Re: BusConnects Galway Cross-City Link Scheme.
University Road to Dublin Road, Galway City.

**Galway City Council Proposed BusConnects
Cross-City Link**

GCCN Submission

Appendix: Observations on the Treatment of Cycling in the Bus Connects Galway Cross City Link (University Road to Dublin Road) Scheme:

TYPICAL SECTION A - A
UNIVERSITY ROAD
LOCATED ON GA SHEET 01
DRAWING REF: BCG-GA-00-01

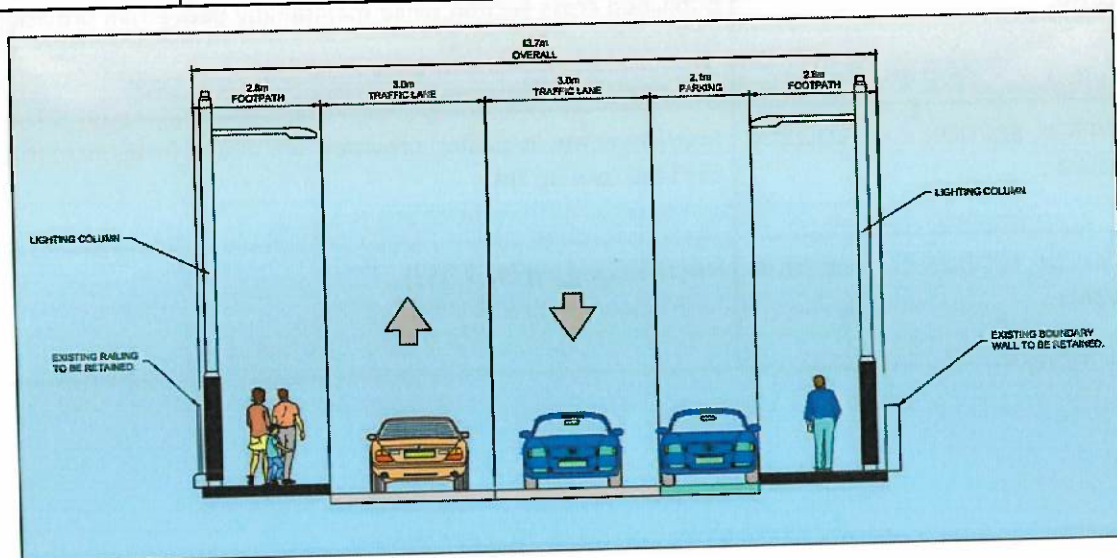
Discussion University Road: If the parking lanes are removed there is scope within the cross section for spacious 2.8m footpaths with wide 4.6m kerb lanes. There is also scope for 2m footpaths, 1.8m cycle facilities and 3m wide general traffic lanes.

There are two sections of on-street parking. The section on the northwest of University road runs along a series of properties that have front gardens - in some cases already converted to driveways. This suggests that other properties at this location could implement driveways and off-road parking, removing the need for on-street parking. On the southeast of University Road there is a section of on-street parking opposite the Millennium Park. If the park is under council ownership then the parking could be relocated to a strip that takes in part of the current park lands.

TYPICAL SECTION C-C
SAINT FRANCIS STREET

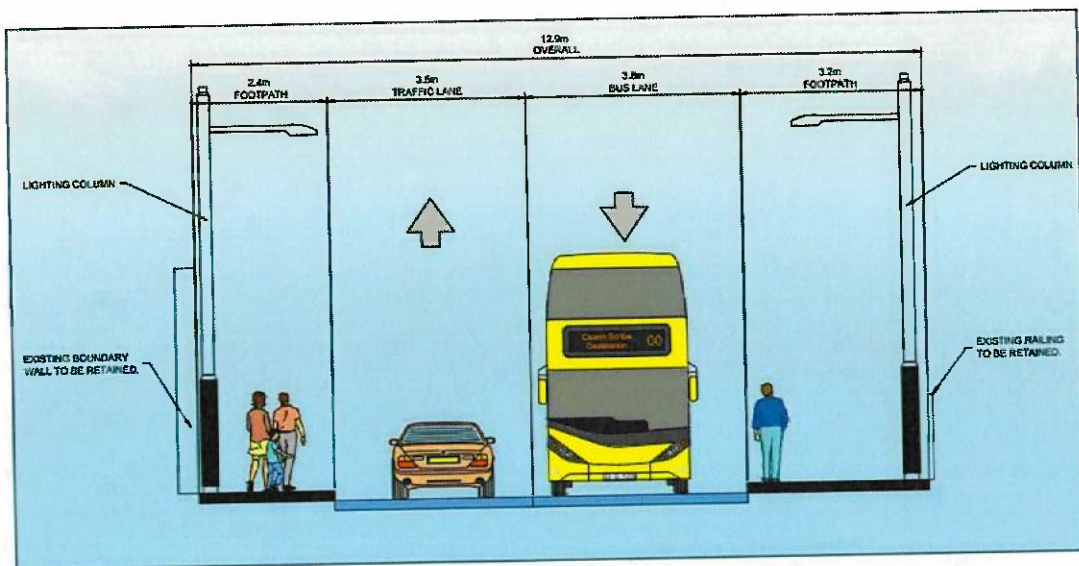
Discussion St: Francis St: The drawings provided in Appendix B2 show that under this scheme Newtownsmith is to be converted to one-way operation going north thus removing it as a means for bicycle users to access Eglinton St. This suggests that Francis St will now be the default way for people on bikes to access Eglinton St/Shop St. The dimensions published indicate that there is room for 2m footpaths with wider 4.4m kerb lanes.

**TYPICAL SECTION E-E
ELINGTON STREET**
LOCATED ON GA SHEET 04
DRAWING REF: BCG-GA-00-04

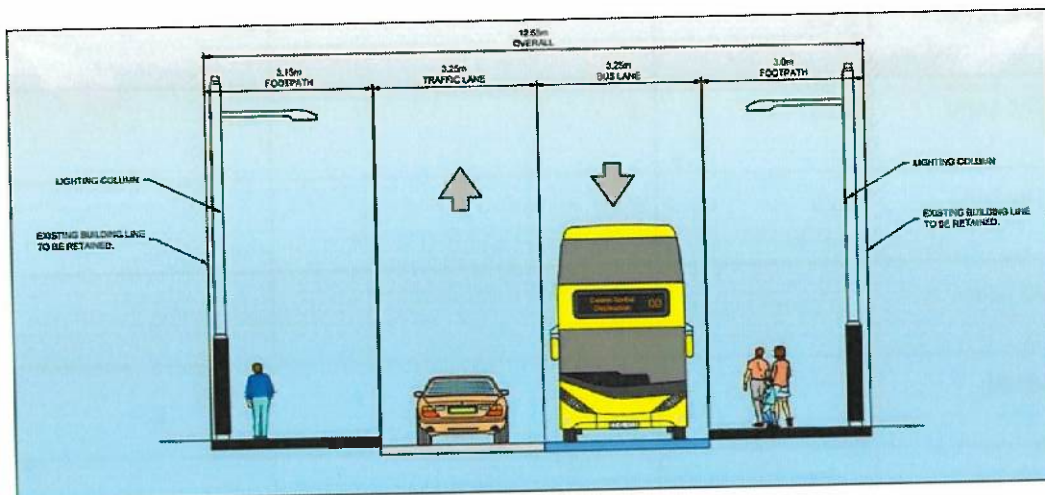
Discussion: Eglington St There is scope within the existing cross section to provide wider kerb lanes 4.3m and 2m footpaths.

TYPICAL SECTION E - F
 BOTHAR BHREANDAIN UI EITHIR
 LOCATED ON GA SHEET 05
 DRAWING REF: BCG-GA00-05

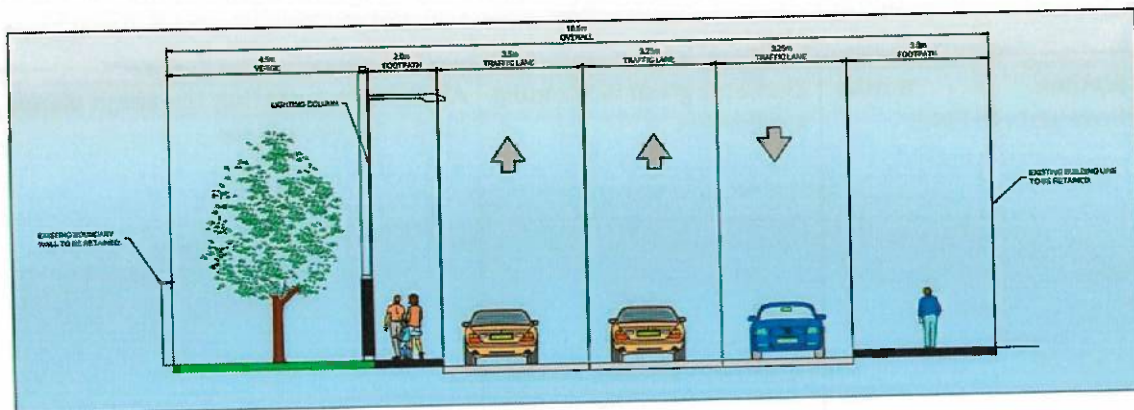
Discussion: Bothar Bhreandain Ui Eithir: By using the 4.5m verge shown in the cross section it is possible to provide 2m cycle facilities on either side of the road.

**TYPICAL SECTION H - H
FORSTER STREET**
LOCATED ON GA SHEET 07
DRAWING REF: BCG-GA-00-07

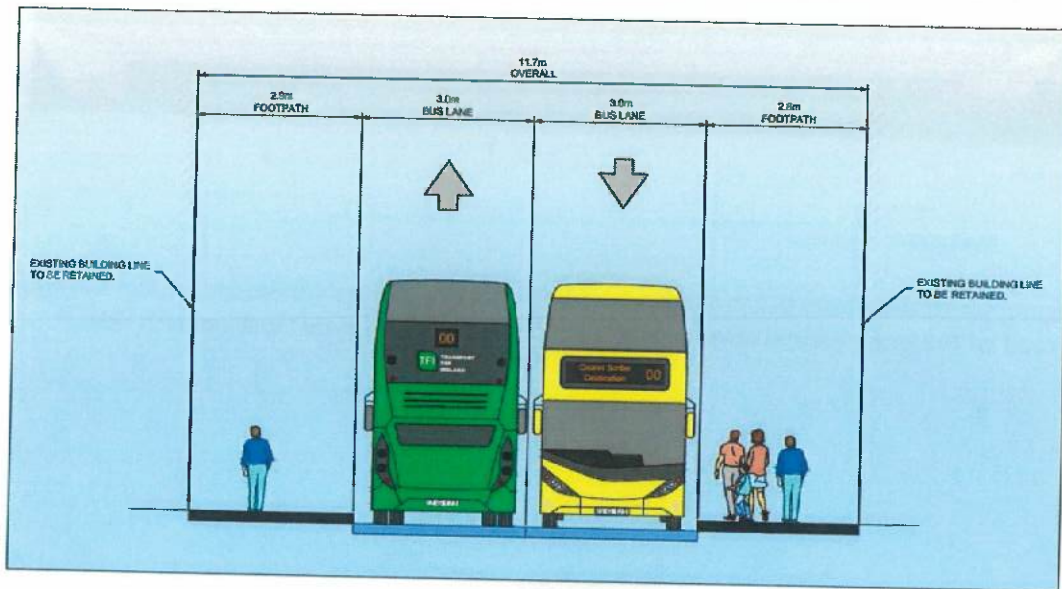
Discussion: Forster St. In the applicant's drawings Forster street is shown as having bus lanes with no apparent provision for cycling. Alternative 1: By using 2m footpaths it is possible to provide wider bus lanes of 3.8m. 3.8m bus lanes are below the necessary width given by some sources. The problems associated with this lane width might be mitigated by omitting a central lane marking and providing some kind of edge marking (hard shoulder marking etc) Alternative 2: This would involve providing wider footpaths and 2m advisory cycle lanes with a single central traffic lane of 3.7m. In this arrangement motor traffic uses the central lane but oncoming vehicles must merge into the cycle lanes to pass each other. This is a type of treatment (sometimes termed "Edge lane roads") that is established in the Netherlands, Germany and Denmark and has seen some use in the UK.

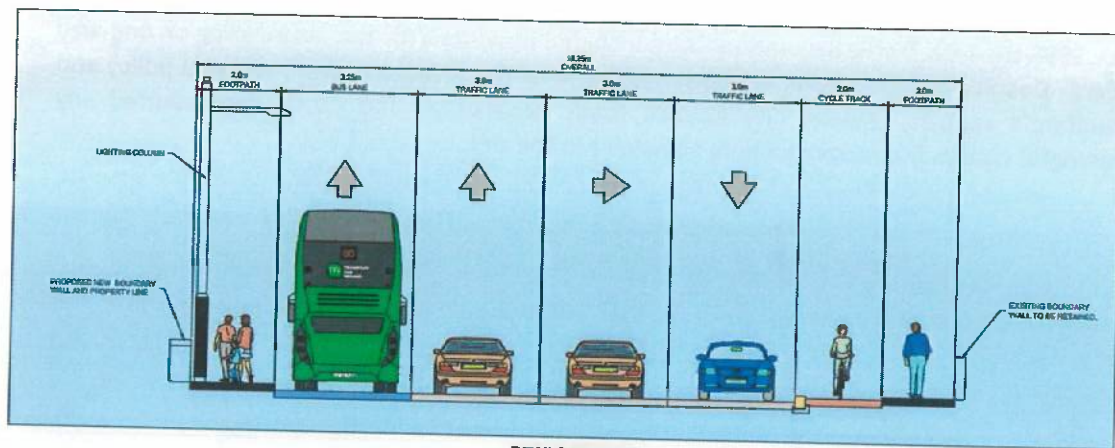
Location: College road (Sportsground)	Elements given in Planning application	Alternative 1: Remove or relocate on street car parking to provide 2m footpaths and 4.6m wide traffic lanes	Alternative 2: Remove relocate on-street parking and provide 2m footpaths and cycle lanes of 1.6m and 3m general traffic lanes
Footpath	2.75	2	2
Cycle lane			1.6

properties at College road already have ample car parking on site. It is also clear that there are lands north of the road that are already used for parking. Also Galway City Council is in the process of vacating the current site at City Hall for another location. Some of the City Hall lands could be incorporated into the scheme to provide for relocated car parking. There are disabled parking spaces on-street at college road and if there is no suitable alternative location then they could be retained. This would interrupt any cycle lanes so coherent and clear markings would be needed to advise drivers to expect people on bicycles at the obstruction.

Extract from drawing Appendix B2 General Arrangements BCG-GA-02 showing new one-way street restrictions circled in red. The orange arrow shows the imposed direction of travel for people on bicycles who try to use the new bridge.

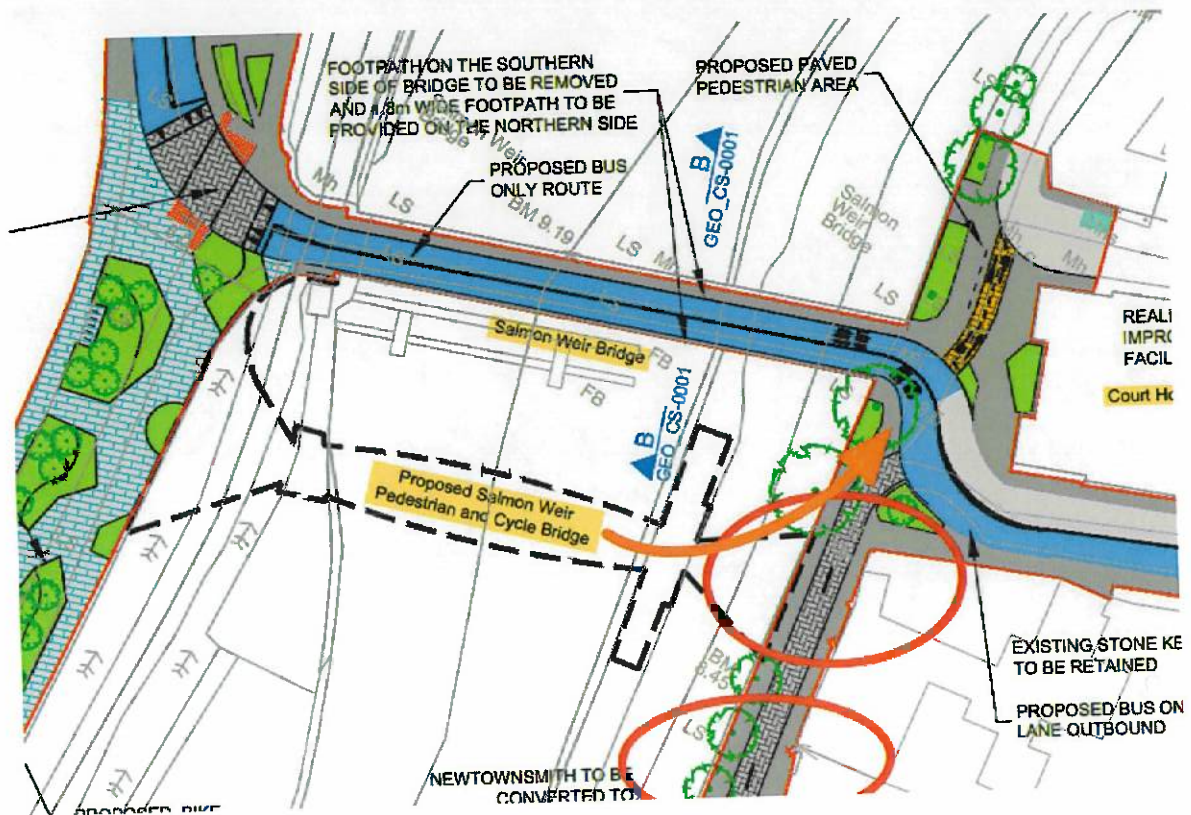
The drawings provided by the applicant show a "Proposed Salmon Weir Pedestrian and Cycle Bridge" linking the cathedral side of the river to Newtownsmith - this bridge is currently under construction. The drawings also show Newtownsmith converted to one-way operation as part of this scheme. The drawings do not show any contraflow arrangements for bicycle traffic at Newtownsmith. The text at *Section 3.2.3 Newtownsmith/St. Francis Street* in the preliminary design report does not discuss the conversion of this street to one-way operation. The text states that cyclists will have access to the bridge "from Newtownsmith" but does not discuss how any bicycle user is supposed to access Newtownsmith from the north or east. The drawings also suggest that any bicycle users crossing on the new bridge from west to east will be required to turn left out onto University Road/St Vincent Avenue to proceed any further. This suggests that, in terms of journey times, the new "cycle" bridge will be of no meaningful benefit to bicycle users coming from the direction of the university or the north-western suburbs of the city. For cyclists coming from the east of the city, there also does not appear to be a meaningful means to access the new "cycle" bridge. This is because Galway City Council operates an extensive system of one-way streets in the city centre, none of which have any contraflow cycling arrangements. All pedestrianised streets are also closed to people on bikes during the period of operation. Because of this system, the only permanently available access

point to streets that would bring cyclists to the new bridge is via Bridge St and Lombard/Market Streets on the west side of the mediaeval quarter of the city.

Merchants Road

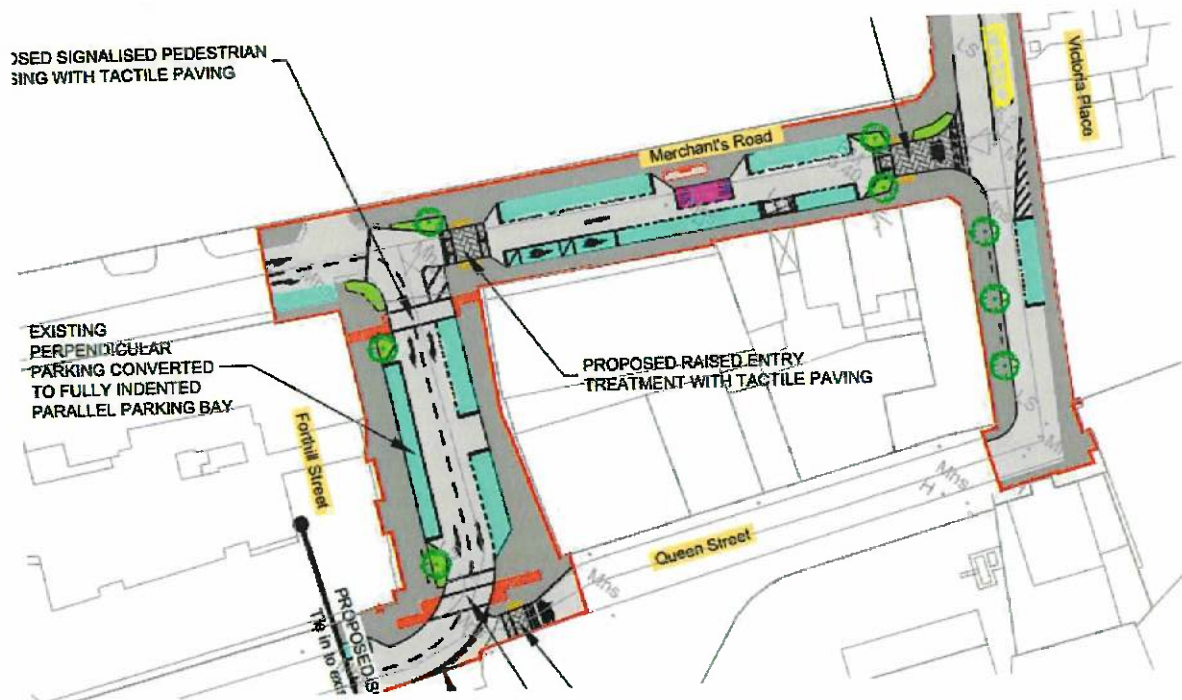
The drawings show Merchants road retained as a one-way street with no provision for contra-flow cycling. This confirms that under the Bus Connects proposals the unsuitable Dock road remains one of only two routes for people on bicycles to access the core of the city from the east. If contra flow arrangements were provided along Merchants road between Abbeygate St and Victoria Place this could be the beginning of an alternative circulation route for bicycle traffic into and through the old core of the city.
